# ENVIRONMENTAL REVIEW TEAM REPORT

## WATERTOWN MUNICIPAL BUILDING SITES

## WATERTOWN, CONNECTICUT

**OCTOBER 1978**

# SURFICIAL GEOLOGY OF THE FRENCH STREET SITE

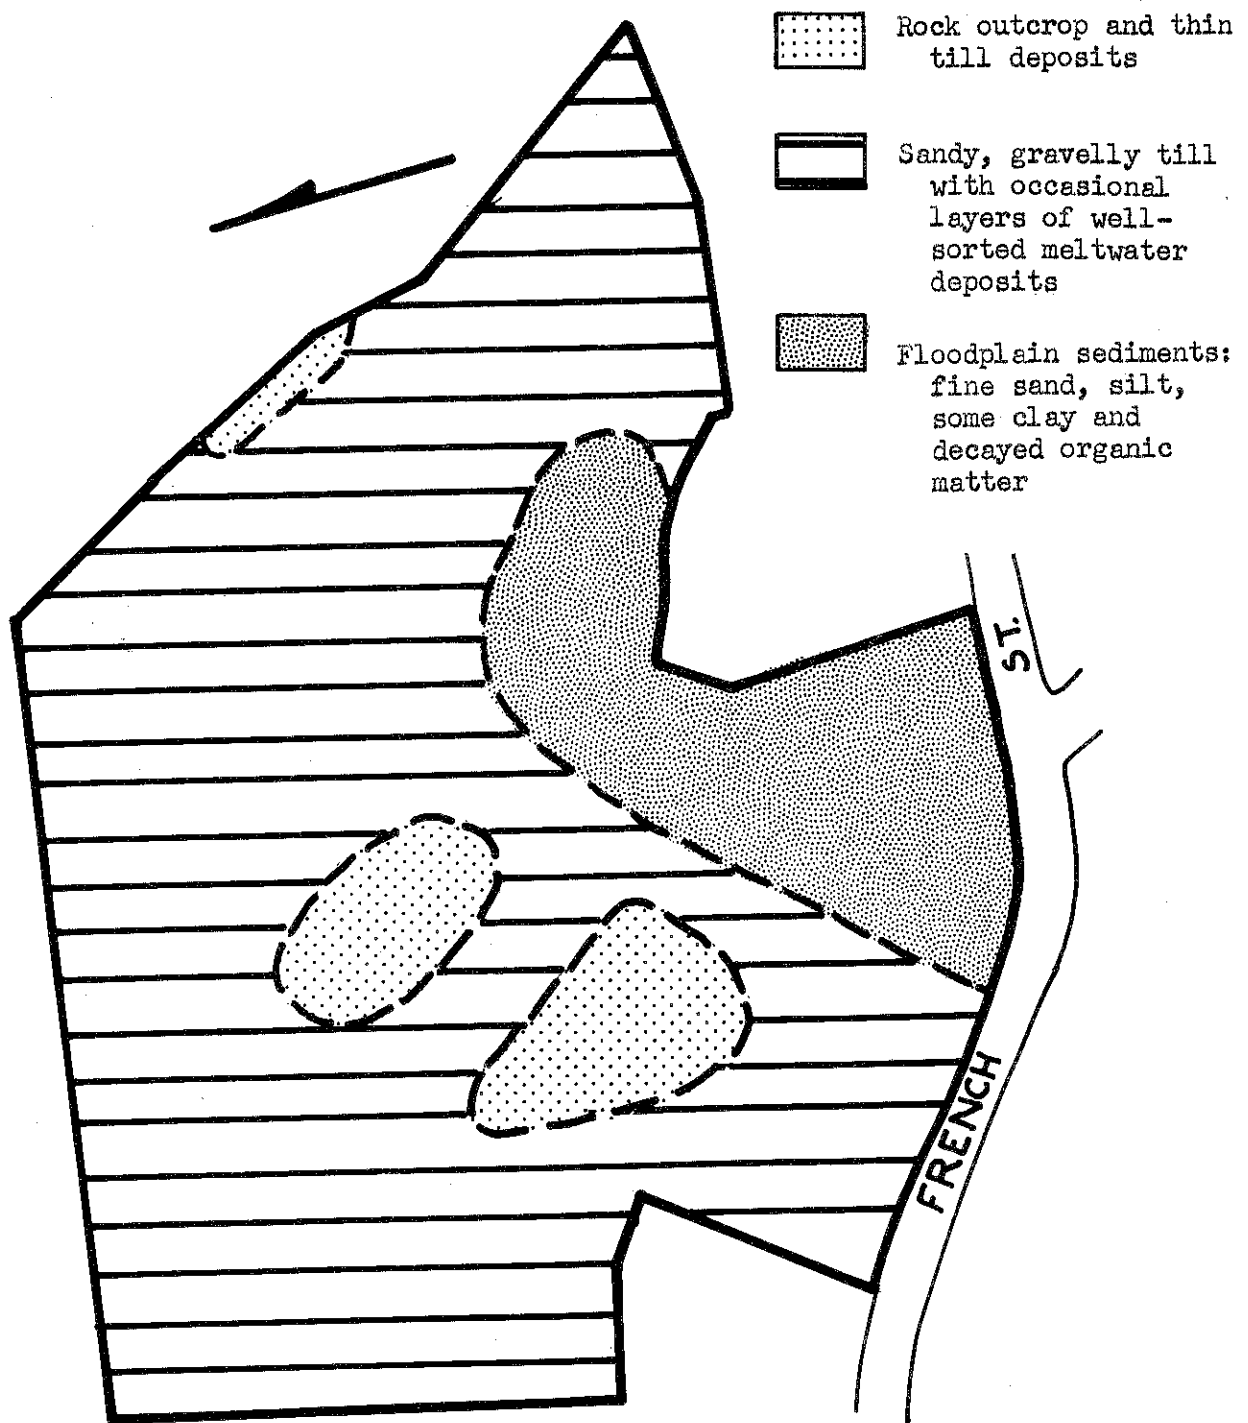
The surficial geology of the French Street property is slightly more complex. Bedrock crops out or is close to the surface of the property in several areas (see figure 2). The overburden apparently consists of a sandy, gravelly till that may in places contain lenses of better-sorted meltwater deposits. In the southeastern section of the property, the till is overlain by fine sand, silt, and some clay and decayed organic materials. These sediments were deposited principally during periods when the brook that flows through this area was in flood. Adjacent to these deposits, to the west, the natural overburden is covered by artificial fill. The fill is not designated in figure 2 because its thickness is not known. In the northwestern section of the property, floodplain sediments form a narrow band along another small stream. These deposits have also been omitted from figure 2 because of their apparent thinness.

# WATERSHED OF FRENCH STREET SITE

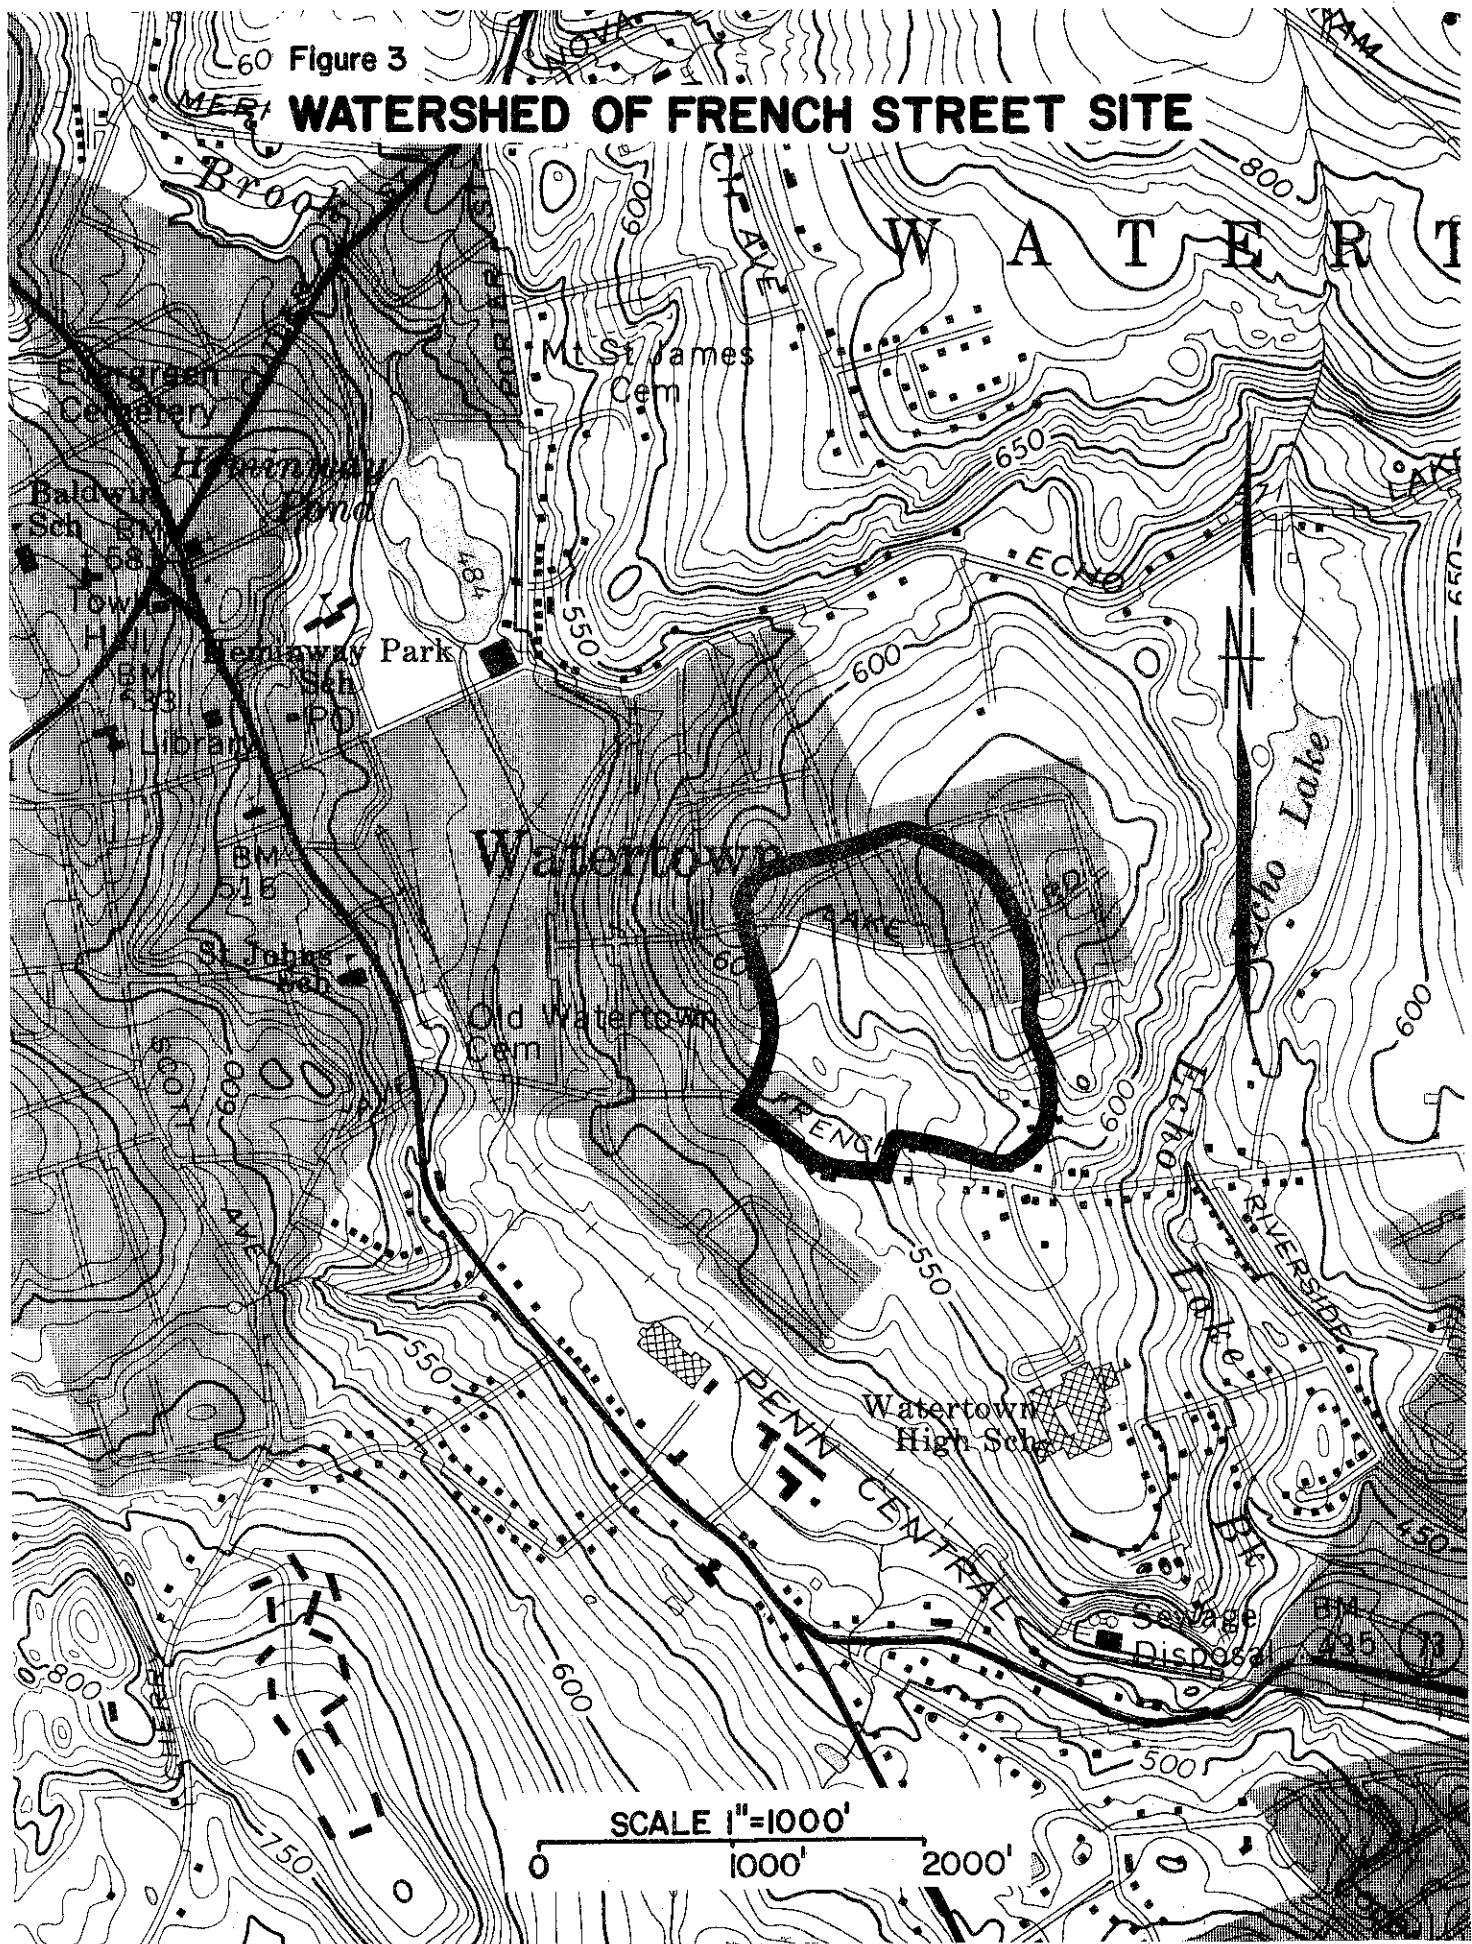
The French Street property lies within a small drainage area (approximately 44 acres; see figure 3) from which runoff is channeled through a culvert under the street. No data was available concerning the adequacy of the culvert to handle peak flows in the brook following heavy rainfall or snowmelt, or on the percentage of time the wetland behind the culvert is ponded. Because of the small size of the overall drainage area, a development of only a few acres of the parcel could cause a noticeable increase in peak flows. The actual percentage of the increase would depend upon the precise size and location of the developed areas, as well as upon the storm drainage measures that would be provided. Nevertheless, it seems safe to conclude that the increase would not exceed 7 percent.

If ponding presently occurs at the upstream end of the culvert during certain-frequency storms, the area involved in the ponding would increase somewhat. However, if such ponding is not presently a nuisance, it is unlikely to become a nuisance following development.

# VEGETATION MAP FRENCH STREET SITE

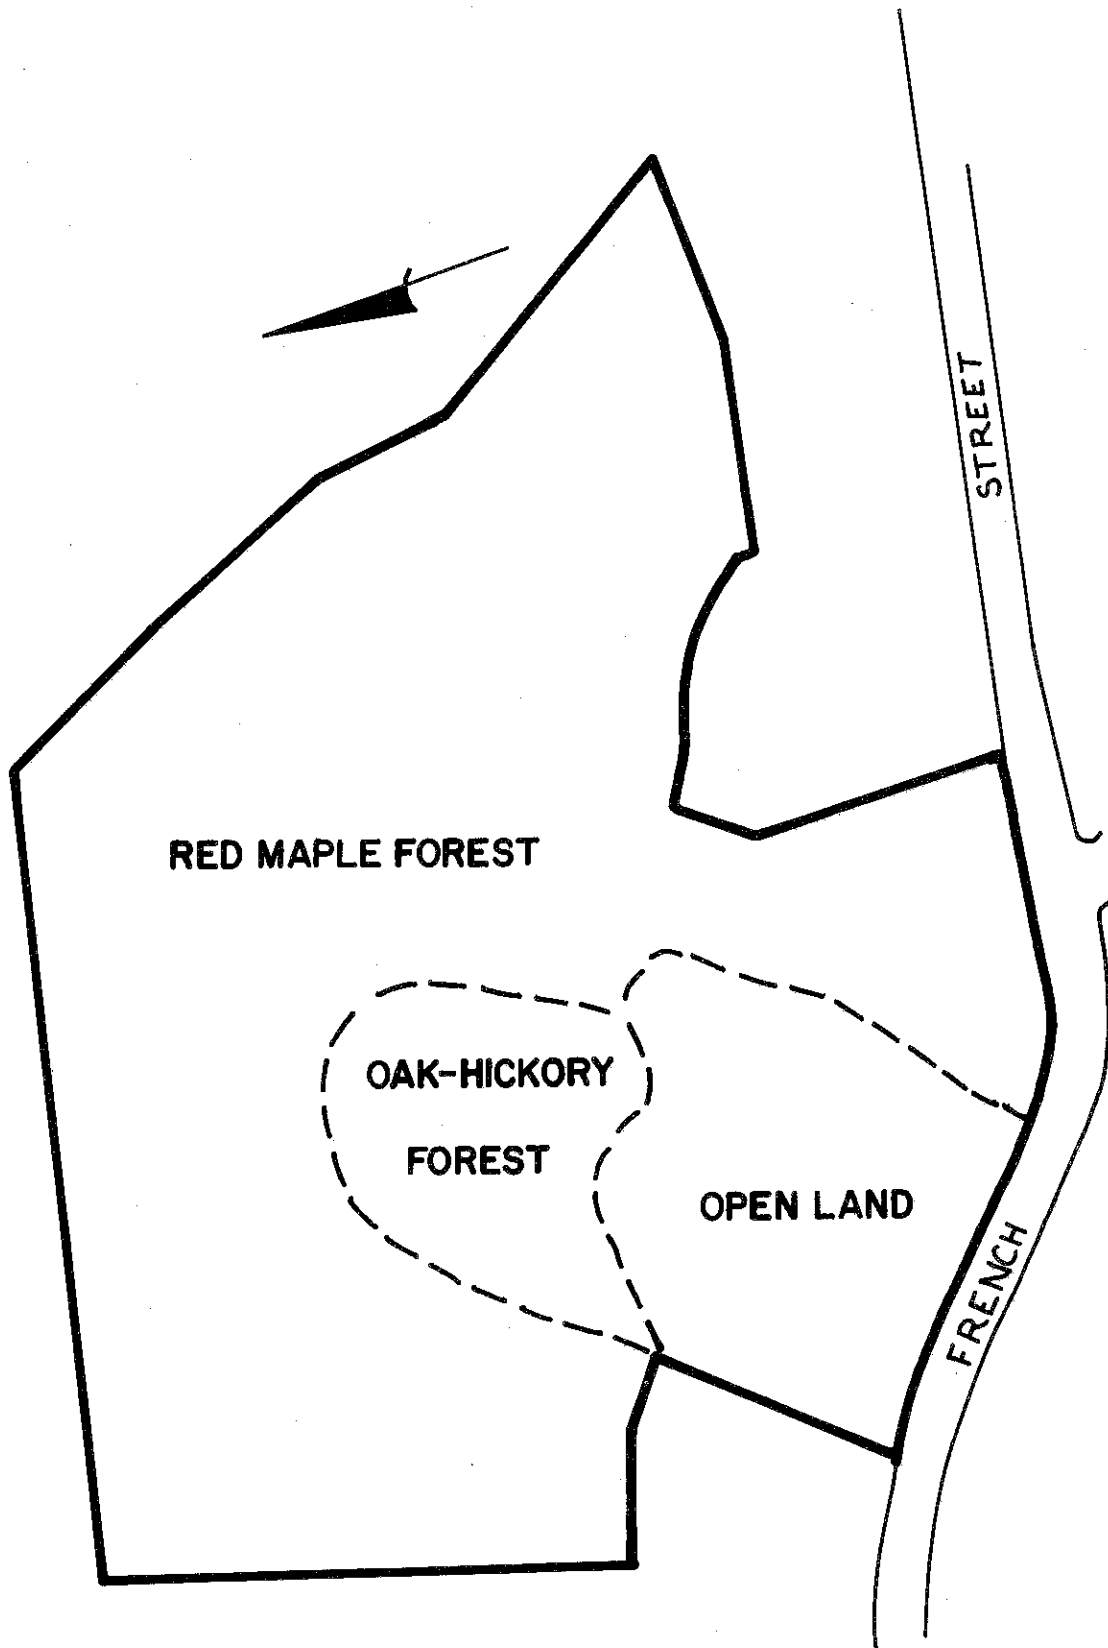
The French Street property is forested with the exception of  $\pm$  3 acres of open land where the property abuts French Street. Two forest types are present on the property. These include a dense pole to sawlog-size stand of red maple and a  $\pm$  2 acre pole size stand of oak and hickory. The red maple stand contains a dense understory of spicebush, barberry, jewelweed and ferns. The oak-hickory stand is not as densely understocked as the red-maple stand. The open field area of the property consists of scattered patches of goldenrod, pokeweed, jewelweed and a variety of grasses.

The high density of trees in the red maple stand creates a blowdown hazard. The wet site aggravates this condition by limiting the depth to which trees are rooted. Several light thinnings, to remove about 20% of the volume each time, would be advisable at 4 - 5 year intervals to provide additional growing space for the most desirable trees. In the event a thinning operation is undertaken, a competent private forester should be retained to mark the trees to be cut and supervise the harvest. A yield of about 2 cords per acre should be produced by the first thinning. The wood should be salable to area homeowners. It should be noted that it will be difficult to remove trees from the interior because of the wet soil and density of the residual stand. Marked trees which are not removed in the initial harvest should be cut by Town employees, to provide the desired thinning effect.

# FRENCH STREET PROPERTY DEVELOPMENT POTENTIAL \*

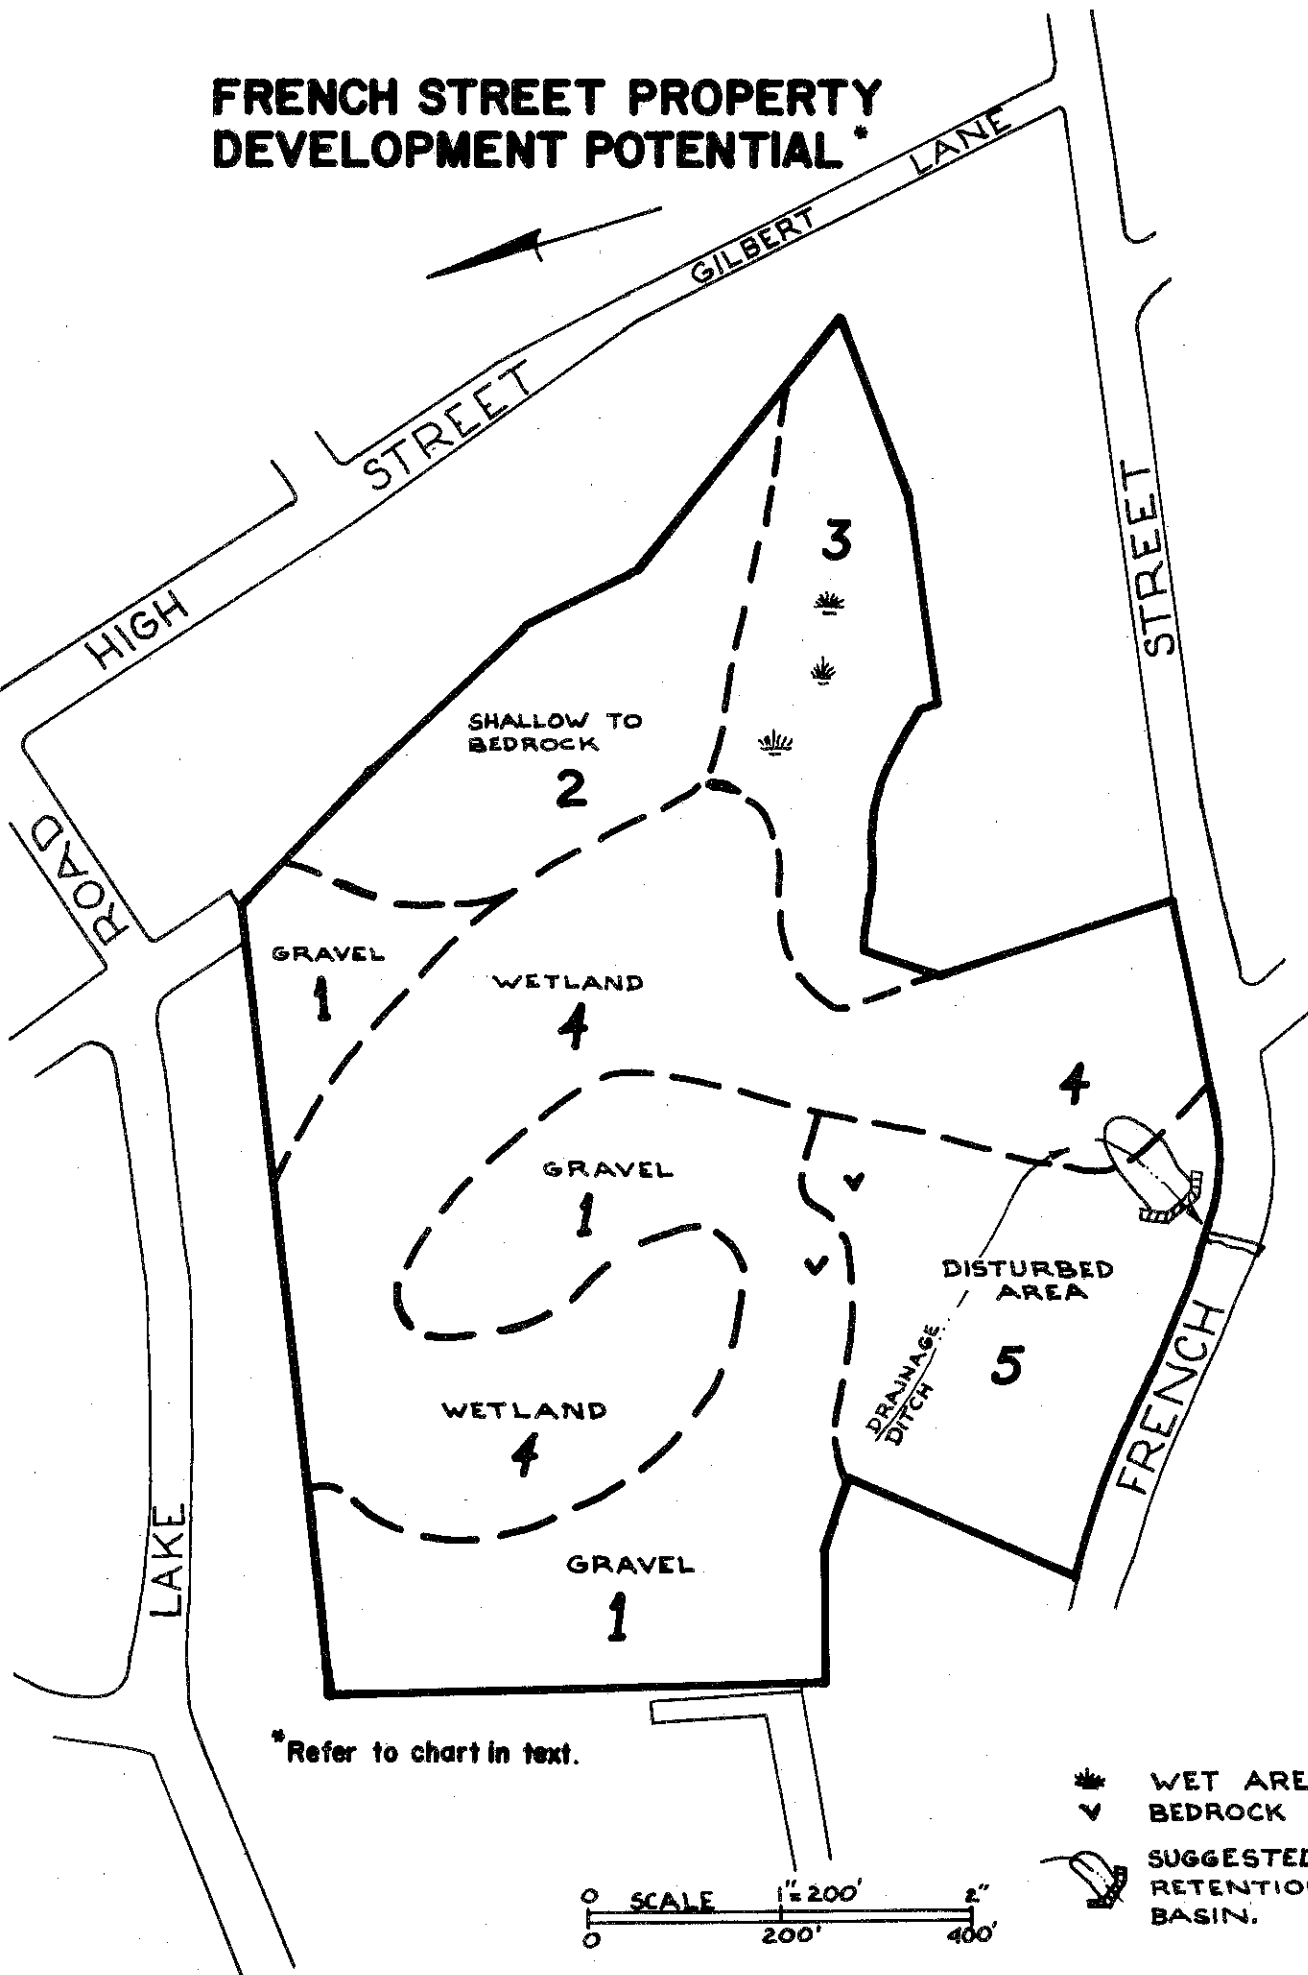
4. Consideration should be given to installing a combination stormwater retention basin and sediment pond (see suggested location on "Development Potential Map" in Appendix of this report). This should be constructed before disturbance of other areas at the site occurs and should be maintained during development. Disturbance of the soil in or around wetlands can cause much sediment to enter the wetland, culverts, or streamchannels downstream. In addition, any development, particularly of the wetland areas, will reduce the capacity of the land to store stormwater after storms. This reduced capacity will cause higher flows downstream after storms. Although the small scope of the development proposed will probably not increase flooding problems substantially (see Hydrology portion of this report) a stormwater retention basin will help to control increased stormwater runoff. Another alternative would be the use of dry wells to deposit roof and other storm runoff directly into gravelly soils.
